NORTHERN BEACHES LOCAL PLANNING PANEL

WEDNESDAY 18 OCTOBER 2023

Agenda for the Northern Beaches Local Planning Panel to be held on Wednesday 18 October 2023

ITEM 4.1	DA2022/1494 - 2A ALLEN AVENUE, BILGOLA BEACH - DEMOLITION WORKS AND CONSTRUCTION OF A DWELLING HOUSE INCLUDING SWIMMING POOL
AUTHORISING MANAGER	Steve Findlay
TRIM FILE REF	2023/626101
ATTACHMENTS	1 ↓ Assessment Report 2 ↓ Site Plan & Elevations 3 ↓ Clause 4.6

Figure 1. Applicant's illustration of the proposed building height breach as measured from the existing ground levels

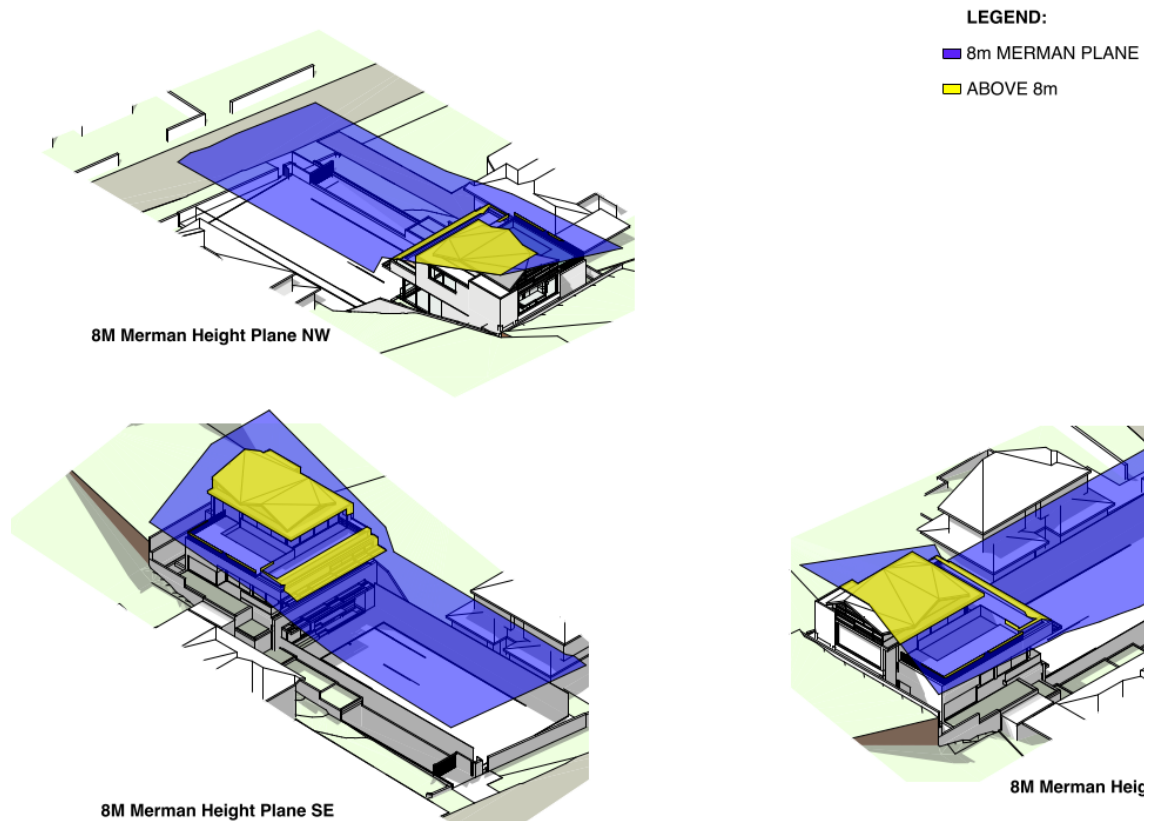
Development standard:	Height of Buildings
Requirement:	8.0m
Proposed:	11.6m
Percentage variation to requirement:	45%

The above height plane diagrams are not certified, however the portions of building projecting above the 8.5m height plane are generally in alignment with Council's calculations, and are presented in a more practical format than a two dimensional sectional drawing. On that basis, the diagrams are included for illustrative purposes. Figure 2 included below indicates Council's calculation of the proposed building height breach.

Figure 3 (Clause 4.6 Figure 5). Applicant's illustration of the proposed building height breach as measured from the assumed natural ground levels

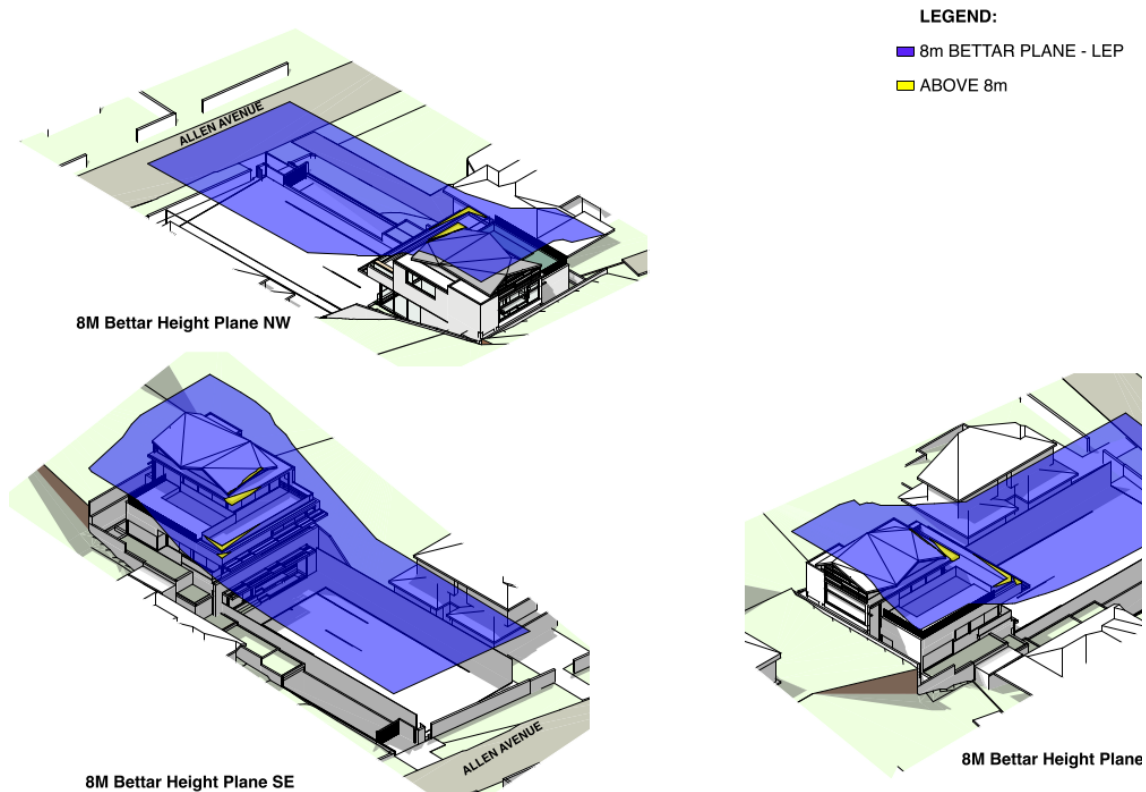
In this regard, I note that the prior excavation of the site within the footprint of the existing building distorts the height of buildings development standard plane overlaid above the site when compared to the natural undisturbed topography of the land. When the original undisturbed levels of the site are interpolated across the building footprint the proposed development would generally comply with the 8 metre height standard as depicted in Figure 5"

The Applicant's Figure 5 referenced in the Clause 4.6 written request is included below. It is noted that the height blanket overlain on the below 3D model is based on *assumed* natural ground levels. Given the irregularity of the topography of the site and surrounds and the extent of the apparent prior alteration of the land, the accuracy of these assumed natural levels cannot be verified or relied upon with certainty.

Figure 6. Northern elevation plan indicating building envelope breaches shaded red

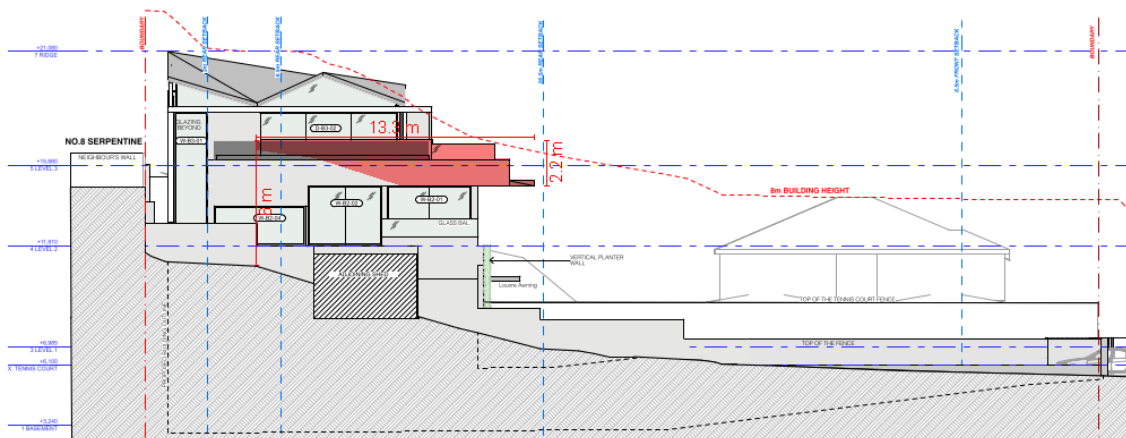
Having regard to the above assessment, it is concluded that the proposed development is inconsistent with the relevant objectives of the control.

Accordingly, this assessment finds that the proposal is **not supported**, in this particular circumstance.

Figure 8. Site/floor plan indicating calculable landscaped areas shaded green

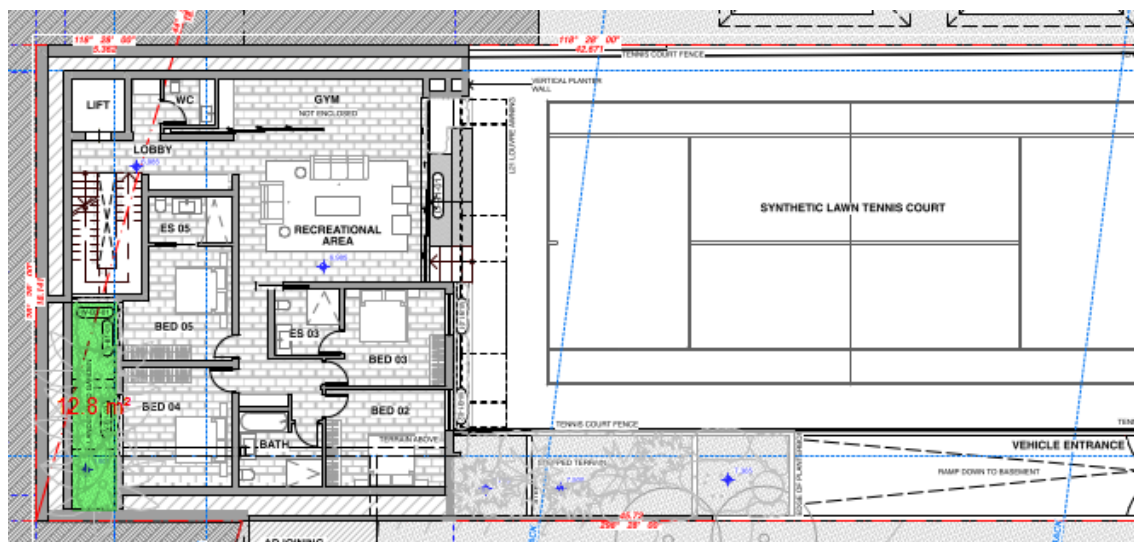
For clarity, Council considers the below areas in green to constitute 'Landscaped Area':
